Groundwater Application Review Summary Form

Application # G- 18470

TO: Water Rights Section Date April 15, 2017
 FROM: Groundwater Section Michael Thoma
Reviewer's Name
 SUBJECT: Application G- 18470 Supersedes review of _____
Date of Review(s)

A. GENERAL INFORMATION: Applicant's Name: Ronald Anderson County: Lane

Water-Level Trends in Nearby Wells

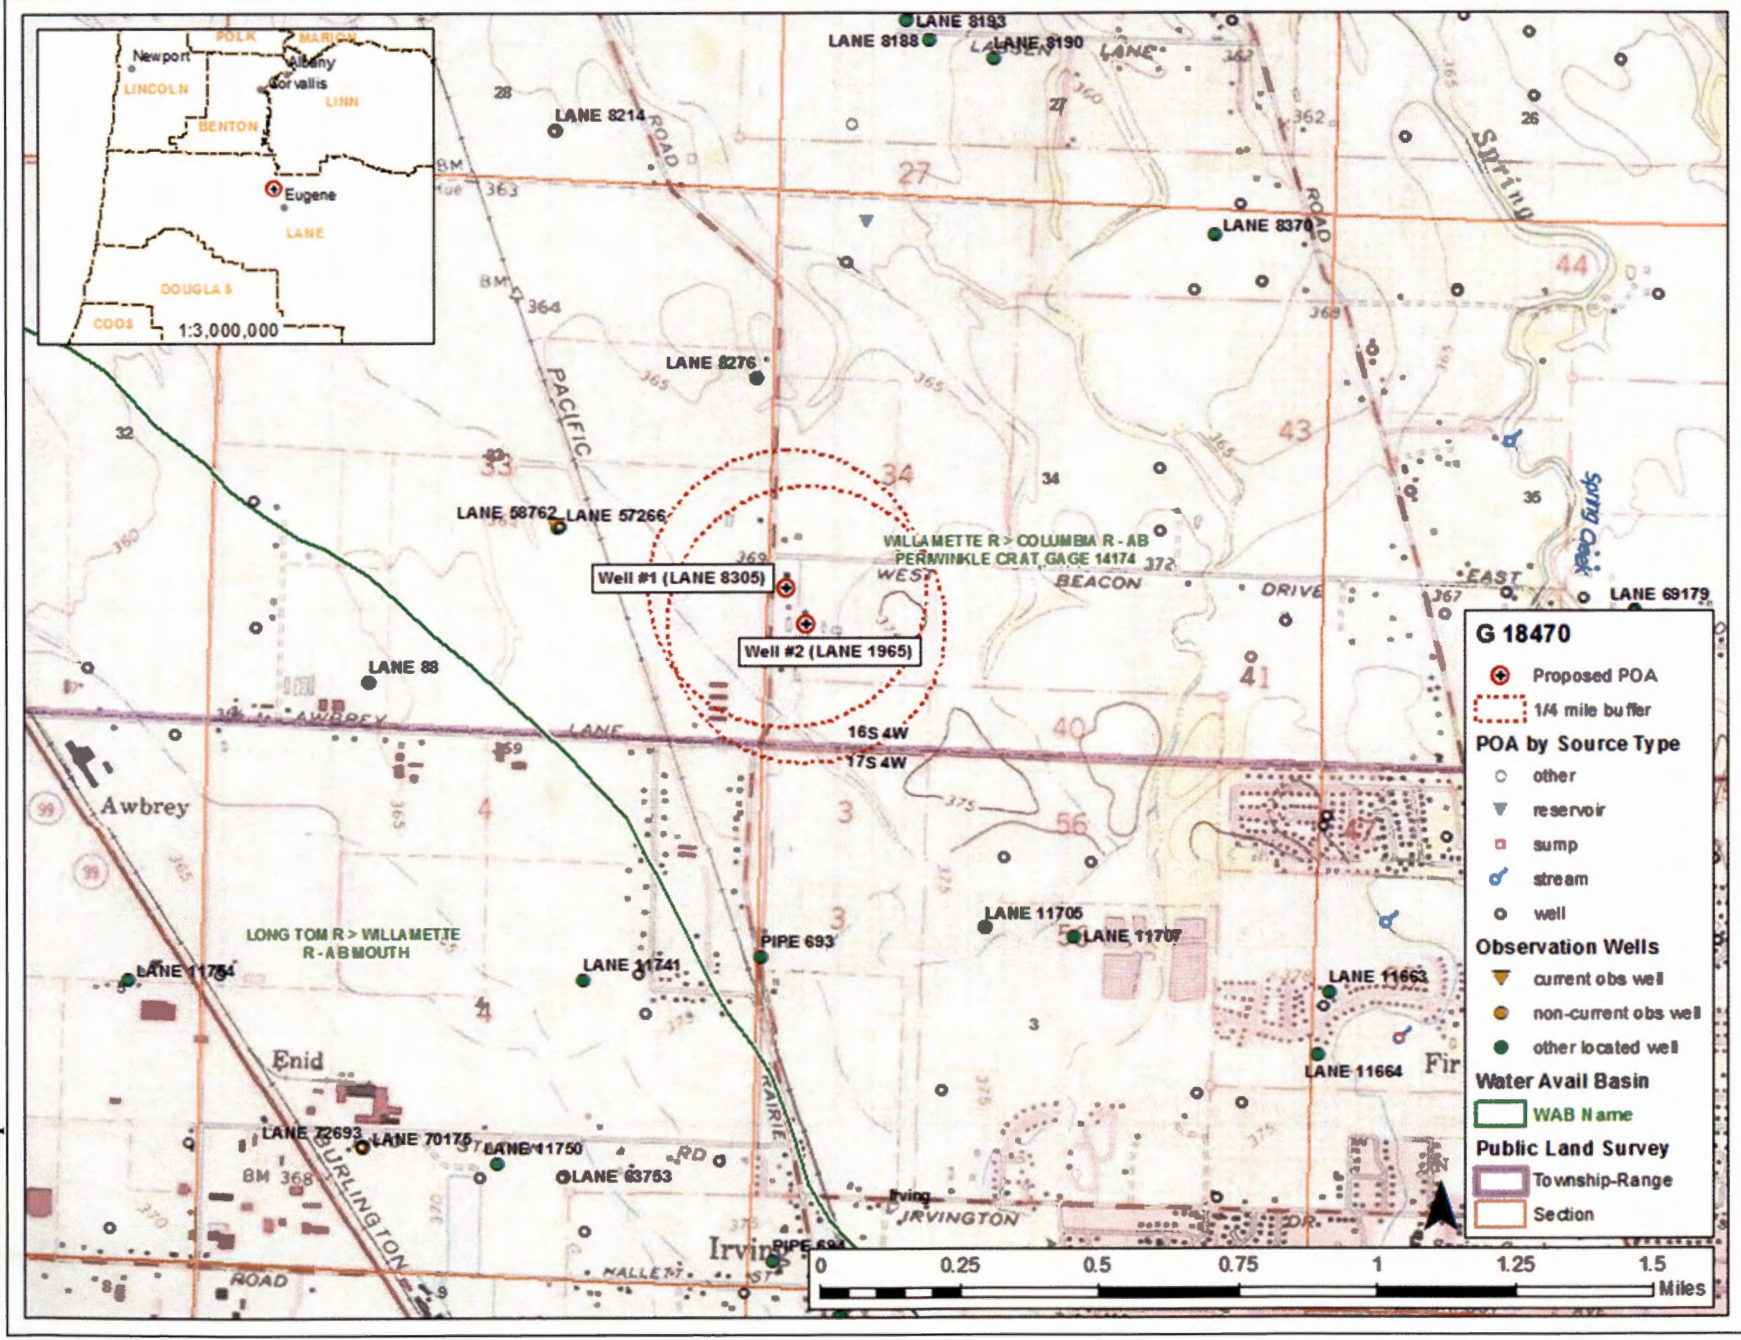
B3. **Groundwater availability remarks:** There is a permit-condition observation well located < 1 mile to the west of the proposed POA (LANE 57266) that has water-level records from 2001 to Present that show stable long-term trends; other wells in the area with less-extensive records show similar trends. This implies that groundwater is not over-appropriated in the area which is likely due to an efficient hydraulic connection between groundwater and surface water.

Stream-Depletion Analysis Results

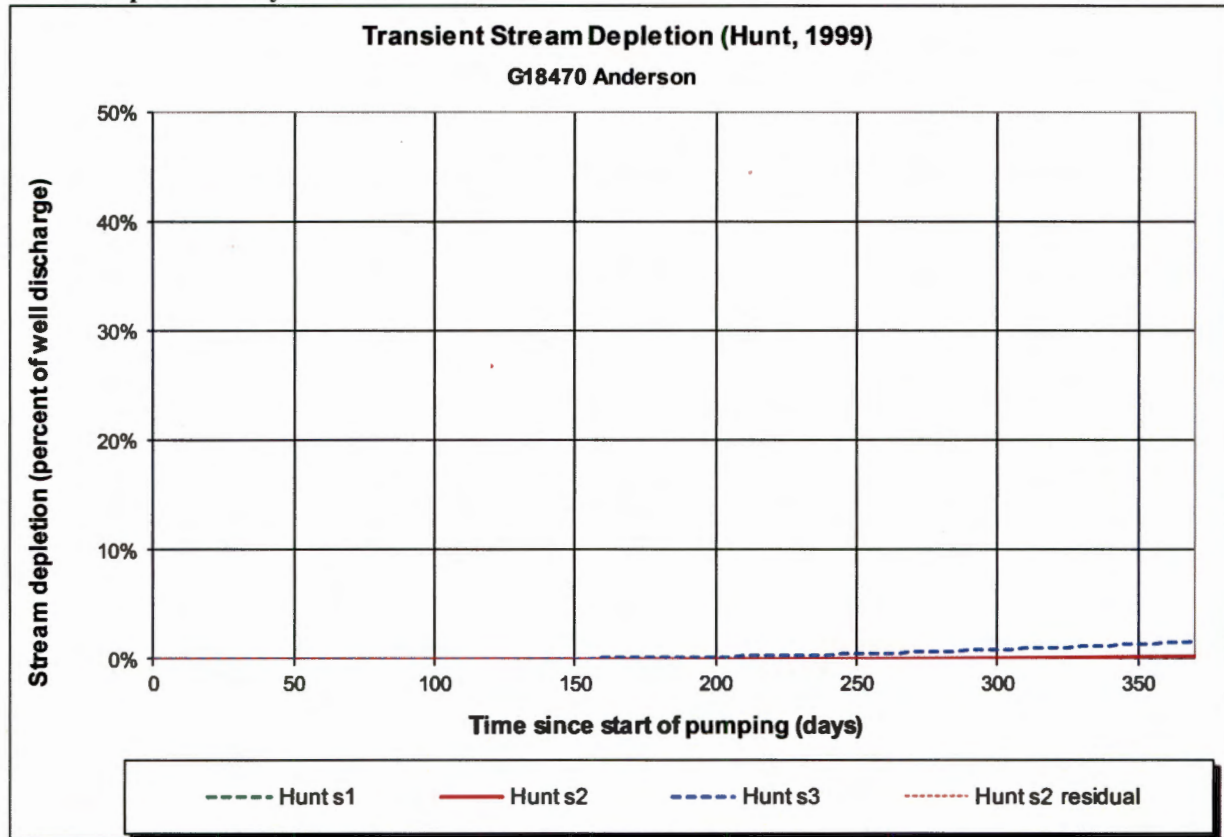
Basis for impact evaluation: The Hunt (1999) stream-depletion model was used to calculate expected impacts from pumping; aquifer parameters were taken from Herrera et al. (2014)

C6. **SW / GW Remarks and Conditions:** The applicant's proposed wells would be producing from an aquifer that has been found to be hydraulically connected to surface water, specifically Spring Creek, at a distance of >1 mile. Analysis of expected impacts to surface water was done and there is not a preponderance of evidence to assume that the proposed use will have the Potential for Substantial Interference (PSI) with surface water
